**PLANNING COMMISSION
Meeting Agenda
Monday – February 8, 2010
7:00 PM - Regular Meeting
City Council Chambers – 155 NW 2nd Avenue**

STAFF REPORT

DR 09-02

300 Block of S. Walnut Street

Scale AS NOTED
Date JULY 31, 2009
Sheet No. **C111**

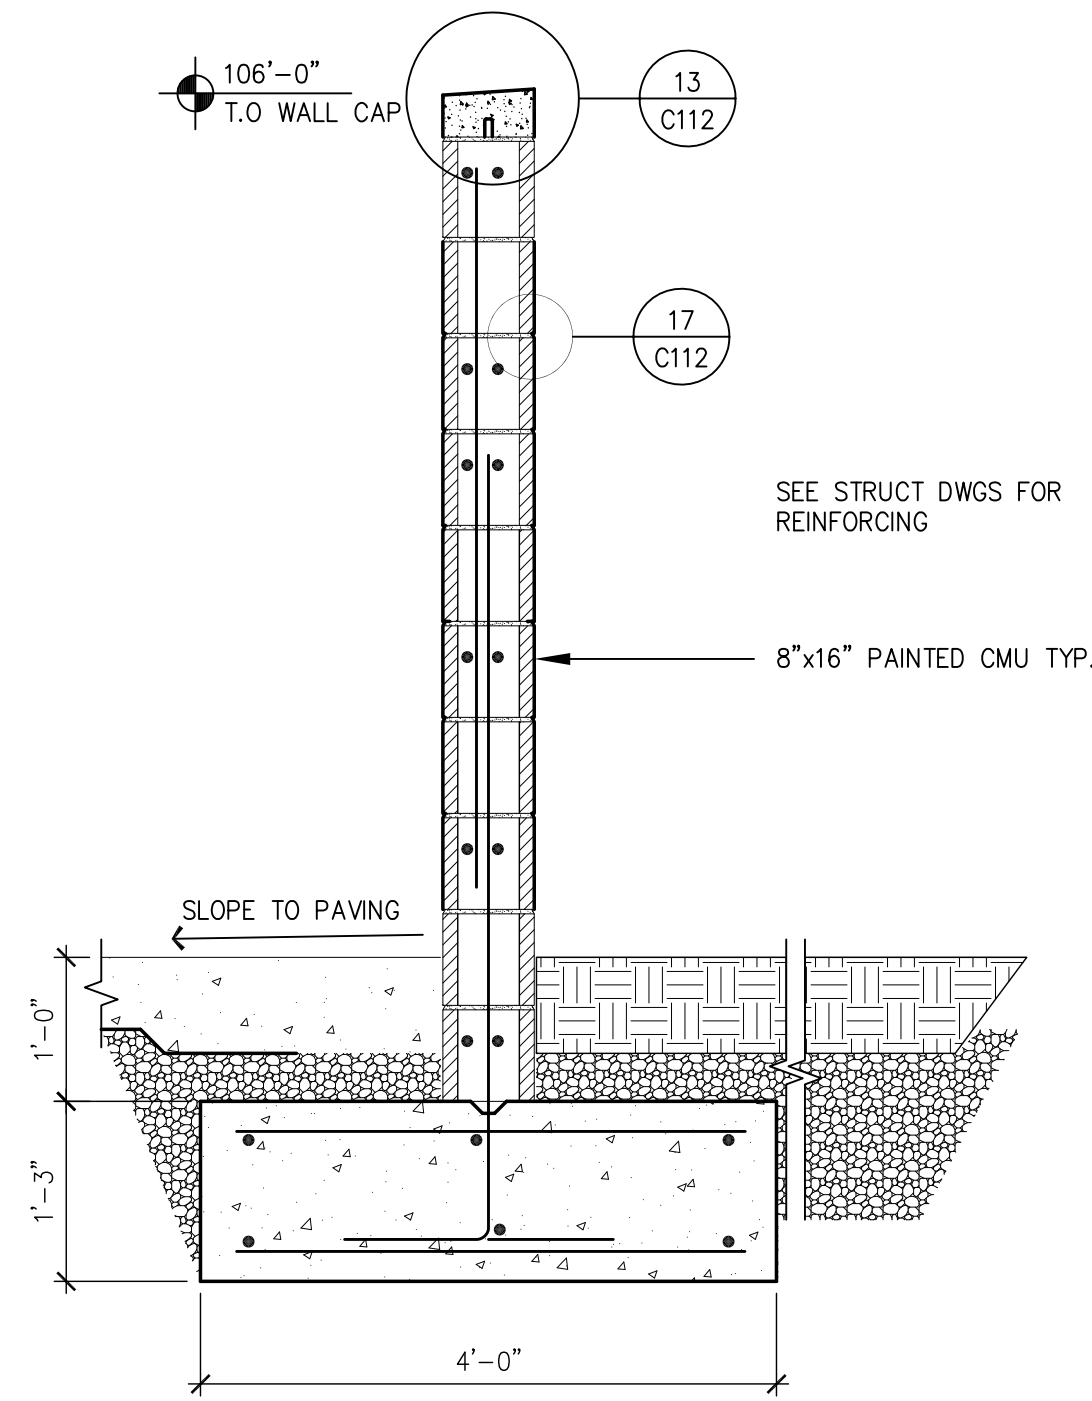
Signs (CMC Chapter 16.42) – As proposed, and with a condition of approval, the development meets CMC 16.42 standards as follows: The applicant has indicated that they plan to install one monument sign near the southerly driveway (*see Exhibit E – callout #17 on sheet C111*). Monument signs must meet all the design standards in 16.42.040, and Table 16.42.050 states that one monument sign, no taller than 6 feet, and not exceeding 32 square feet per sign face, is allowed per lot. CMC 16.42.040 permits the street yard setback for signs to be half of that required for other structures in the zone, so the proposed monument sign could be as close as 10 feet from the right-of-way, provided that vision clearance is met. There is no evidence the proposed monument sign will not be able to meet all the standards. A condition of approval is recommended to approve the placement of one monument sign in the approximate location indicated on sheet C111, provided all applicable standards are met.

Minimum Acceptable Score = 4 Points	8 Points
Transportation/Circulation	
Proposed local street alignments: street not proposed = 0; street(s) proposed with some modifications to master plan = 1; proposed street(s) approximate recommended alignments = 2. Note: the planned parkway and collector streets are required elements, except as indicated by the Industrial Area Master Plan.	
Analysis: The master plan states that the alignment of S. Walnut Street is flexible; therefore the proposed alignment approximates the recommended alignment.	2
Design of all pedestrian ways (private, on-site pathways): six feet wide, raised concrete with painted crosswalks ("standard") = 0; standard with brick or similar pavers for pathways and crosswalks = 1; greater than 6 feet wide (inclusive of curb) and use of brick or similar pavers for pathways and crosswalks = 2.	
Analysis: Most of the proposed pedestrian walkways are six feet wide, with the exception of the pathway that connects the site to the neighboring lot to the north, and the pathway along the southern wall of the building, both of which are 5 feet wide. The pathways are concrete with a painted crosswalk (see Exhibit E – sheet C111).	0

Number of pedestrian connections between the street sidewalk and internal circulation system: one connection = 0; two connections = 1.	
Analysis: Two pedestrian connections proposed (see Exhibit E – sheet C111).	1
Minimum Acceptable Score (some provisions may not apply) = 3 Points	3 Points
Tree Retention, Open Space Conservation and Trail Connections	
Preserves trees as recommended by arborist or City Planning Department: <50% of recommended trees preserved = 0; 50%-75% = 1; 75%-100% = 2	
Analysis: Not applicable. There are no existing trees on the project site.	NA

- One monument sign is approved, to be located in the approximate location indicated on sheet C111 of Exhibit E to the February 1, 2010 staff report, provided that the sign meets all applicable sign standards, setbacks, and vision clearance standards. The property owner shall obtain a sign building permit from the City prior to construction. Any application for additional signage shall be reviewed administratively through the normal sign application process, rather than as a Site and Design Review Modification application. (*condition # 13*)

13. One monument sign is approved, to be located in the approximate location indicated on sheet C111 of Exhibit E to the February 1, 2010 staff report, provided that the sign meets all applicable sign standards, setbacks, and vision clearance standards. The property owner shall obtain a sign building permit from the City prior to construction. Any application for additional signage shall be reviewed administratively through the normal sign application process, rather than as a Site and Design Review Modification application.

Sheet No. **A301**

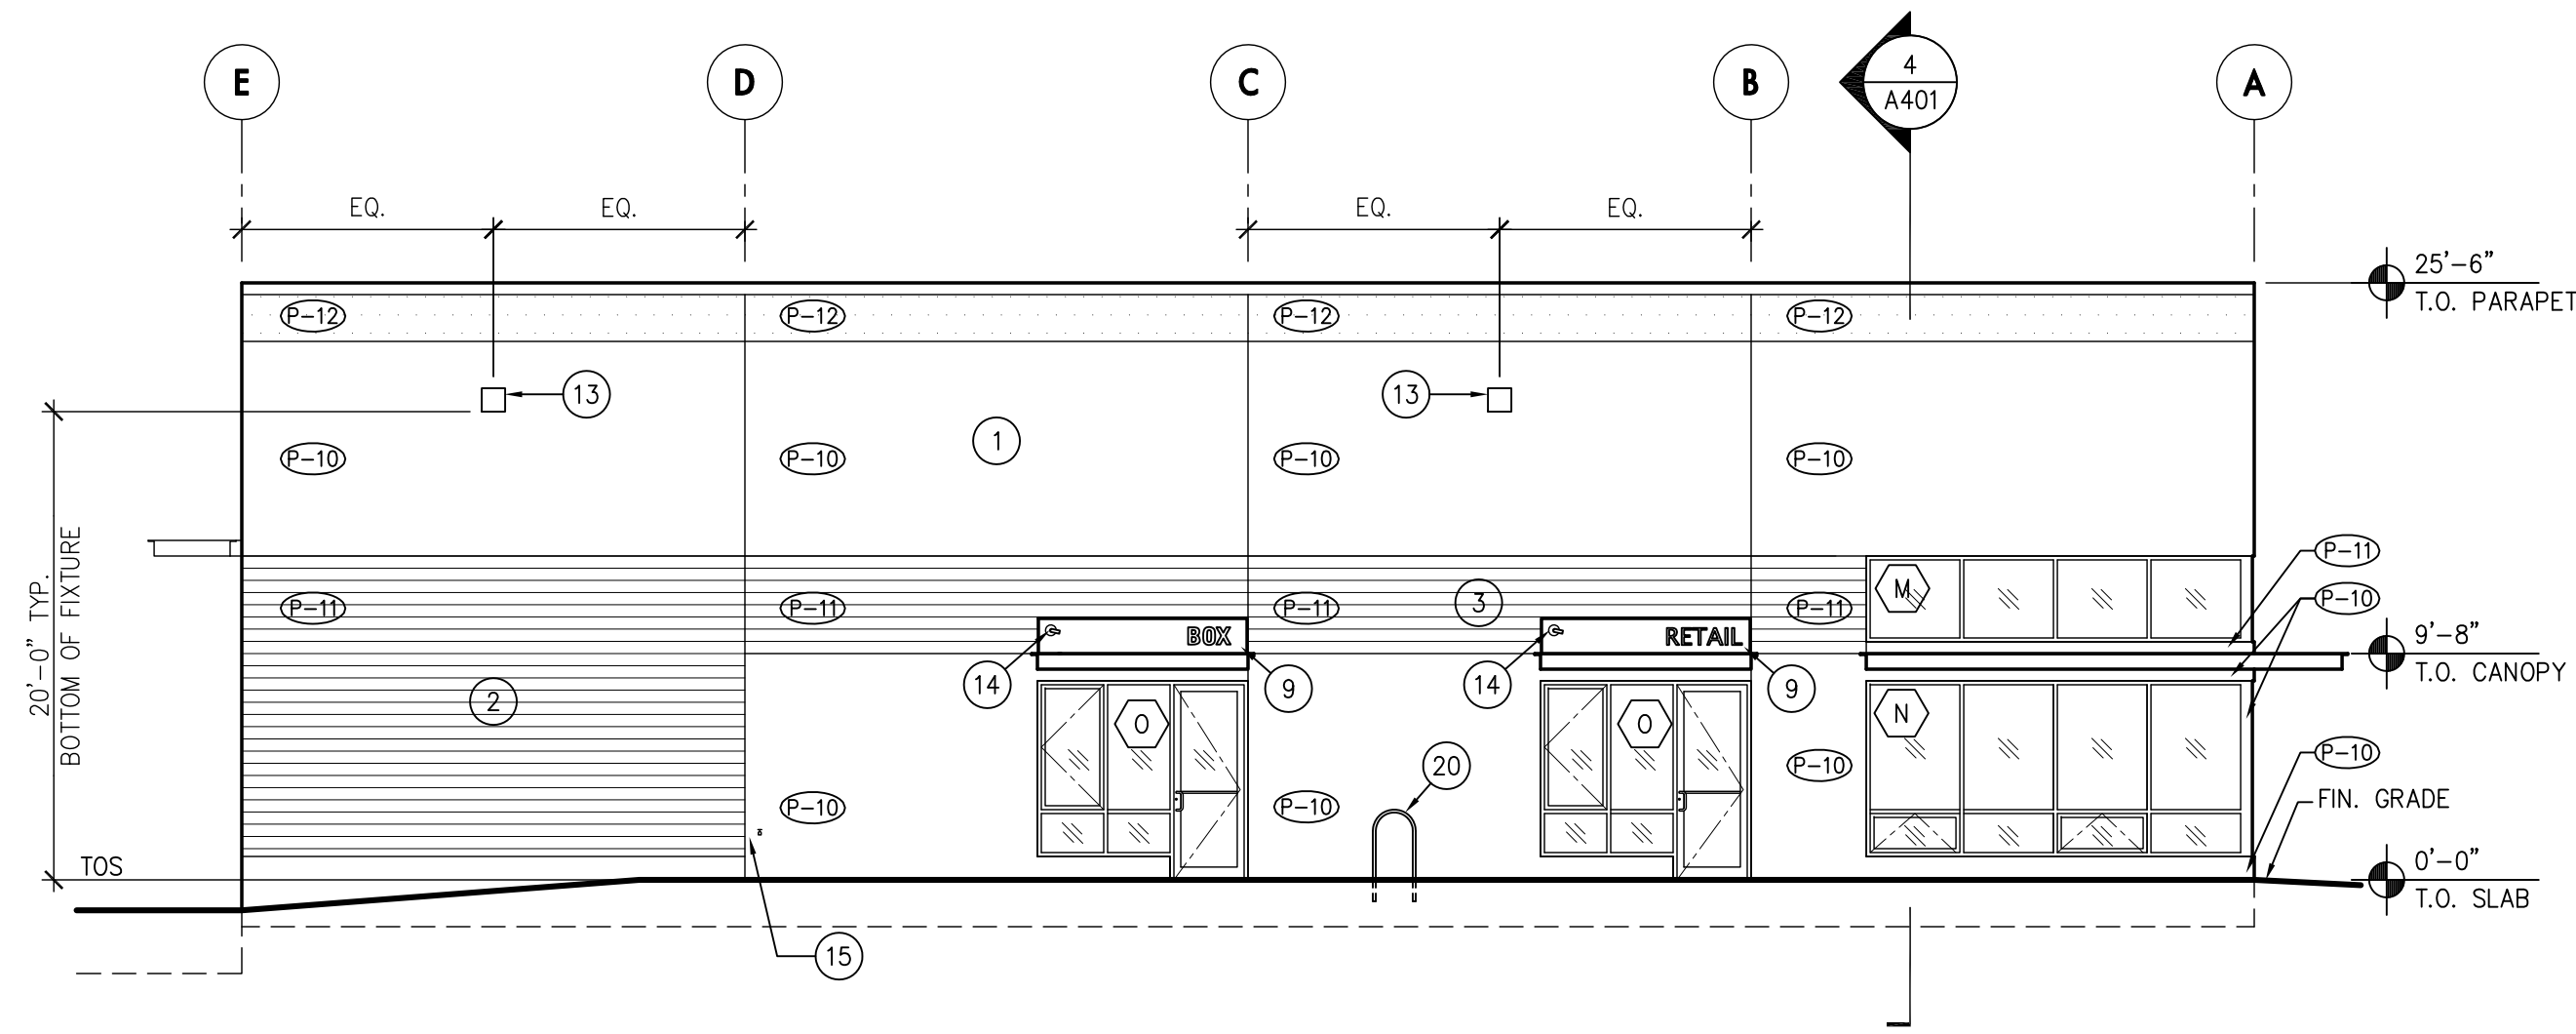
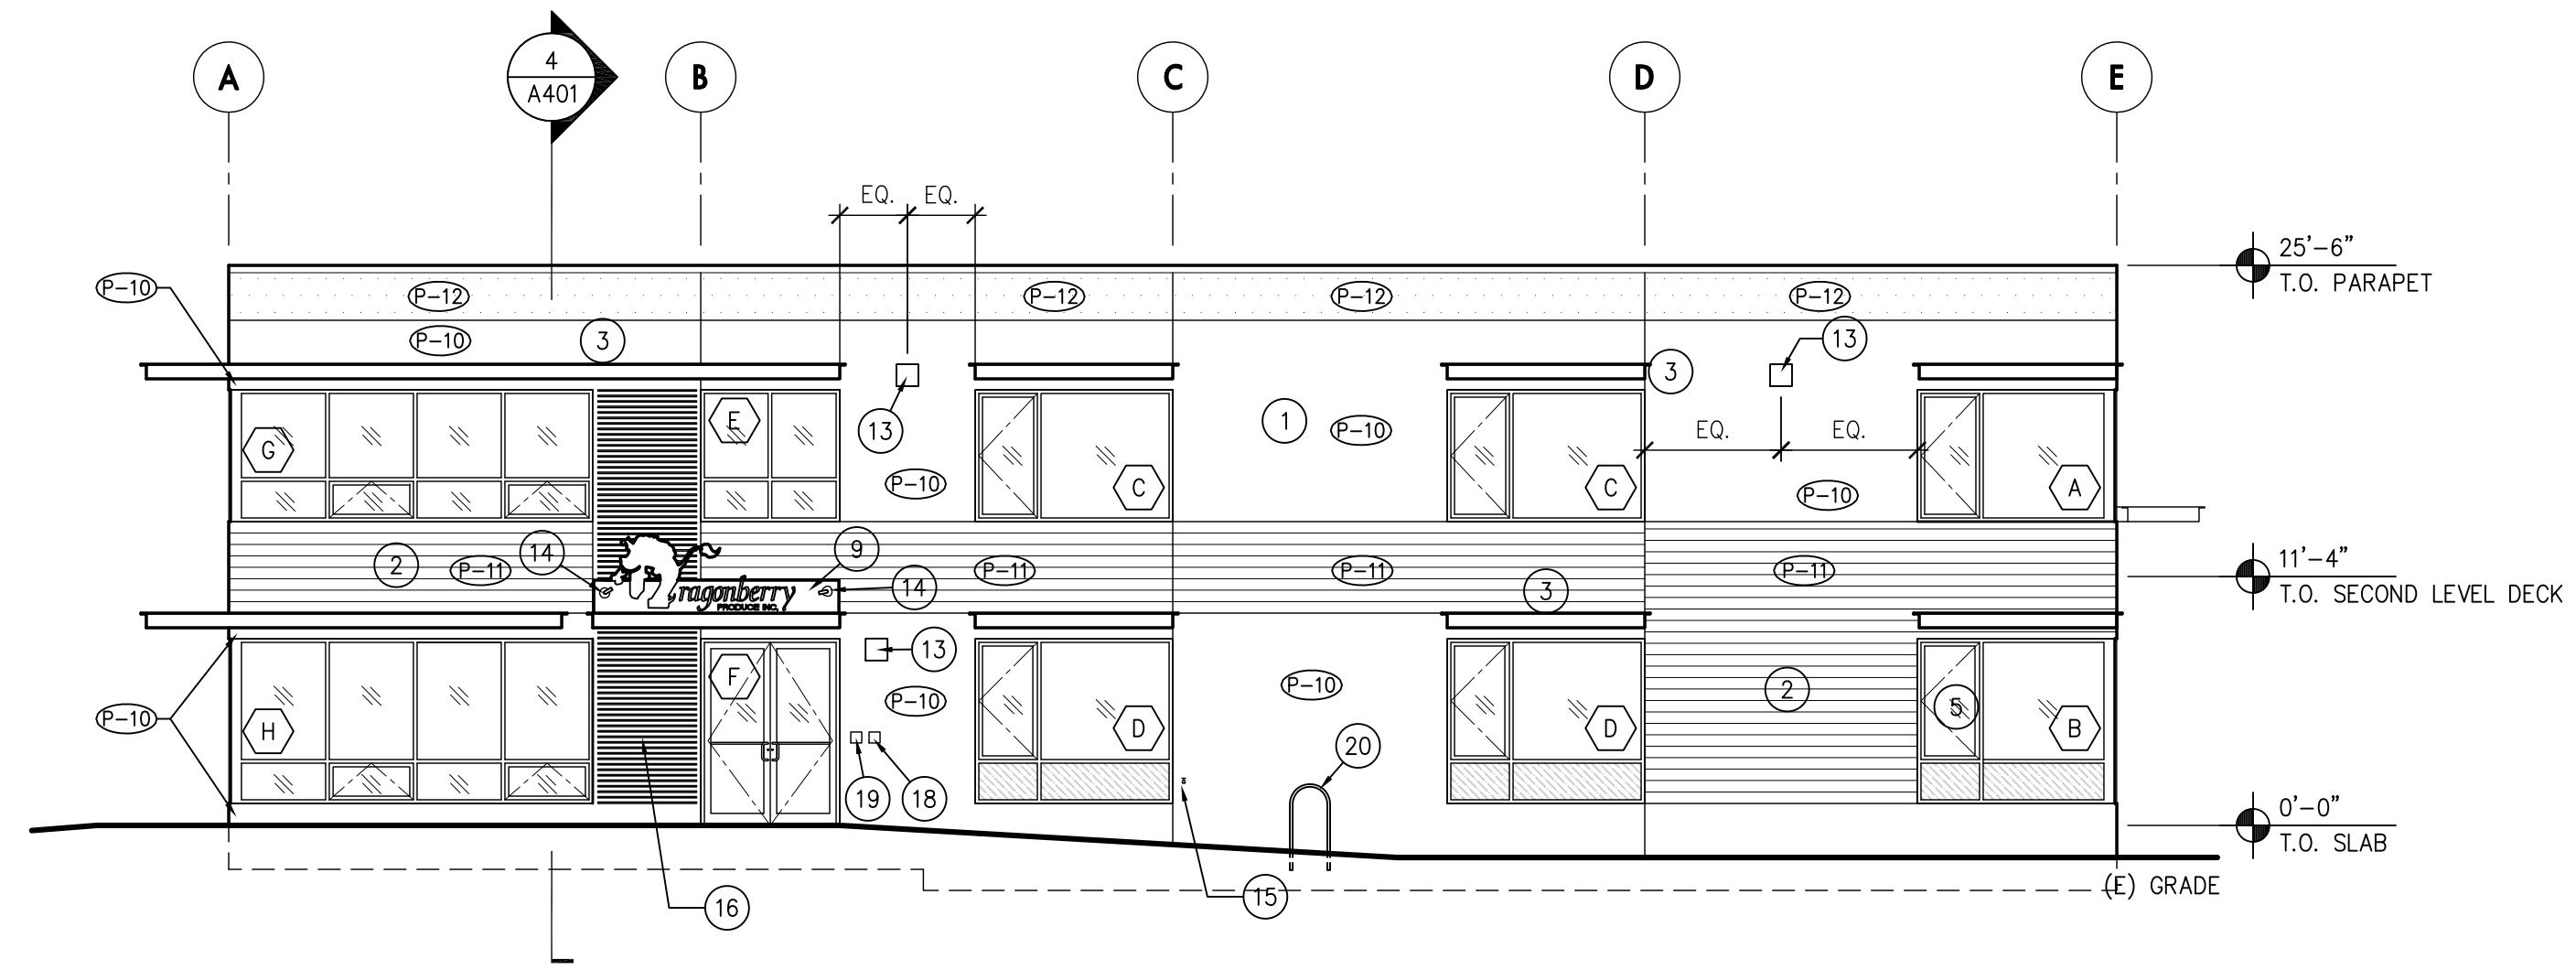
The applicant has also indicated that they plan to install two canopy signs on the west building elevation, and one canopy sign on the east building elevation (*see Exhibit E – sheet A301*). Table 16.42.050 states that only one canopy sign is allowed on each building frontage for each business license on file with the city, and that the maximum sign face area of all canopy signs allowed on a primary frontage is 12% of the building elevation area, up to a maximum of 120 square feet. Both the west and the east building elevations meet the definition of a “primary building frontage”, so the total square footage of all canopy signs that would be permitted on each building frontage is 120 square feet. There is no evidence that the anticipated canopy signs could not meet all required sign standards, provided that two business licenses are issued for occupants of the building prior to the 2nd canopy sign being installed on the west building elevation. A condition of approval is recommended to permit the property owner to apply for sign permits and have them reviewed through the normal sign application process, rather than require a Site and Design Review Modification application.

Usable Outdoor Amenity

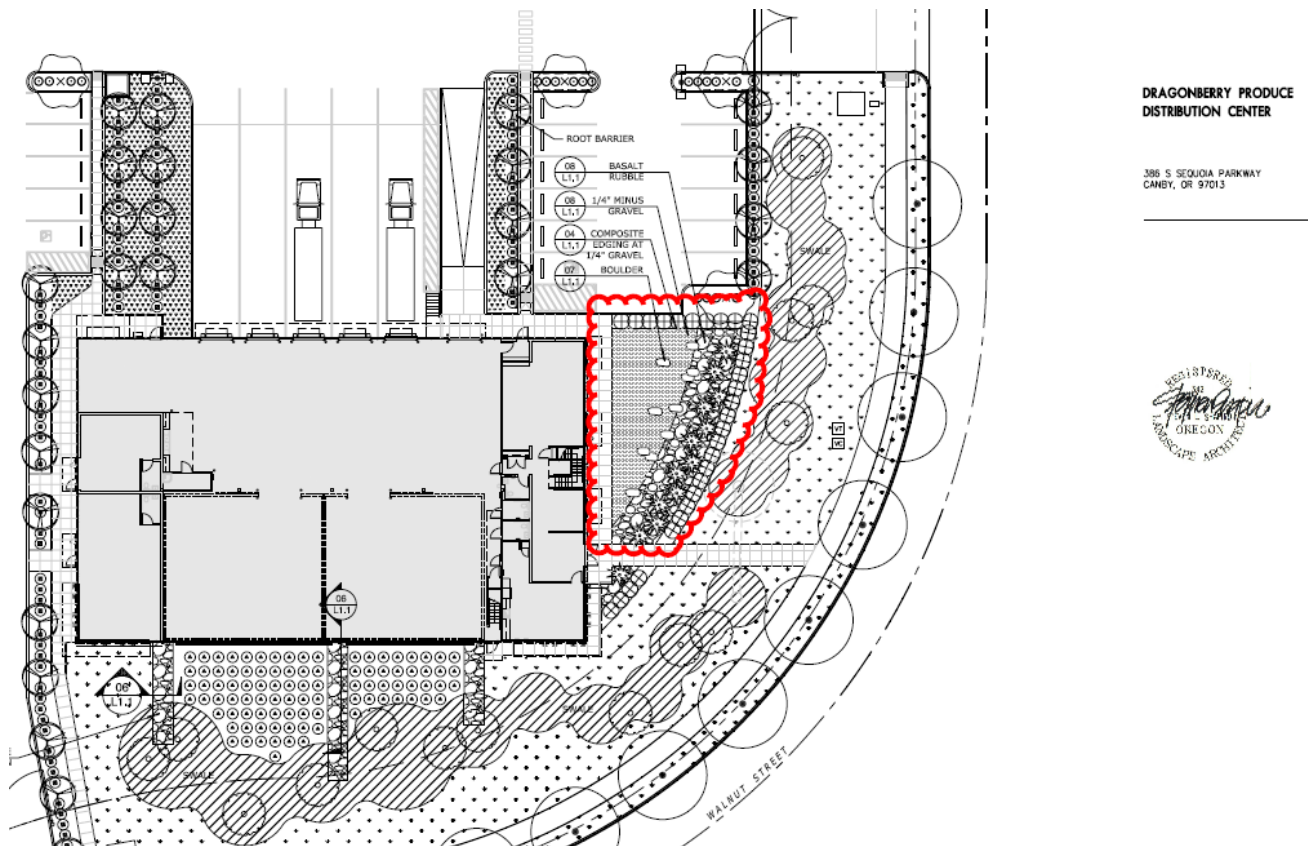
Analysis: Proposal includes a zen rock garden designed for congregation and contemplation, with seating to be provided by appropriately-sized boulders placed in and around the rock garden (see Exhibit E – sheet L101). Public access through recorded public easement has not been proposed by applicant.	1
Amount of grass or other planting used for ground cover treatment: <75% = 0; 75%-90% = 1; 90%-100% = 2	
Analysis: The only landscape area that isn't vegetation is about 10% of the area covered with pea gravel and boulders and a few rock swales under the downspouts.	2
Minimum Acceptable Score = 3 Points	3 points
Building Appearance and Orientation	
Building orientation at or near street; parking or drive separates building from street = 0; at least 20% of elevation within 5 feet of minimum setback = 1; at least 20% of elevation is at minimum setback = 2	
Analysis: Entire building is more than 40 feet from front lot line.	0

Figure 2. Variance Request

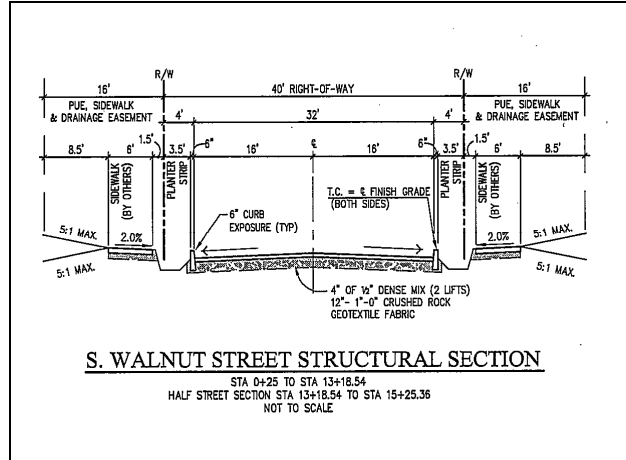
Variance #2 : A request to waive the CMC 16.35.050.G code requirement that street right-of-way improvements be made in accordance with the circulation plan and streetscape/street section standards of the Industrial Area Master Plan. This request is made by the Applicant and by the City Engineer, who has designed an alternative street section standard for S. Walnut Street that is different than the code requirement (*see Exhibit G*), as part of a S. Walnut Street Local Improvement District (LID) street construction project. The LID was approved by City Council in October 2008.

- 16-foot-wide travel lanes instead of 14-foot-wide lanes, recommended by the Public Works department to better accommodate truck traffic, and
- 5-foot-wide street tree planter strips instead of 6-foot-wide planter strips, because the planter strips in all other areas of Canby are only 5-feet-wide, and

The only potential material impact from granting the variance comes from the reduction in the ROW width, from a 52-foot-wide ROW to a 40-foot-wide ROW. Required setbacks for buildings, parking, and other structures are measured from the ROW line. If you look at the street section detailed in the code (*see Exhibit G – Figure 1*), the ROW line falls at the outside edge of the sidewalk, which means that if a 27-foot-tall building is required to have a minimum street yard setback of 35 feet, there will be a minimum of 35 feet between the building and the edge of the

sidewalk. The setbacks in the code were established based on the public sidewalk being located in the public ROW. Now if you look at the new alternative street section (*see Exhibit G – Figure 2*), the ROW line no longer falls at the outside edge of the sidewalk, and the edge of the sidewalk is 7.5 feet outside of the public ROW. Therefore a 27-foot-tall building required to have a minimum street yard setback of 35 feet will now be located 27.5 feet behind the edge of the sidewalk, instead of 35 feet behind the edge of the sidewalk.

- A reduced Right-of-Way width is permitted for S. Walnut Street, as detailed in Figure 2 of Exhibit G to the February 01, 2010 staff report. As a result, the way in which street yard setbacks are measured shall be modified for this site as follows: (A) street yard setback for the 14,458 square foot building approved as part of DR-09-02 shall be measured from the ROW line; (B) street yard setback for all other structures or buildings which may be approved for this site in the future shall be measured from the outside edge of the public sidewalk (the sidewalk edge that is furthest from the centerline of the ROW). (*condition #5*)

5. A reduced Right-of-Way width is permitted for S. Walnut Street, as detailed in Figure 2 of Exhibit G to the February 01, 2010 staff report. As a result, the way in which street yard setbacks are measured shall be modified for this site as follows: (A) street yard setback for the 14,458 square foot building approved as part of DR-09-02 shall be measured from the ROW line; (B) street yard setback for all other structures or buildings which may be approved for this site in the future shall be measured from the outside edge of the public sidewalk (the sidewalk edge that is furthest from the centerline of the ROW).
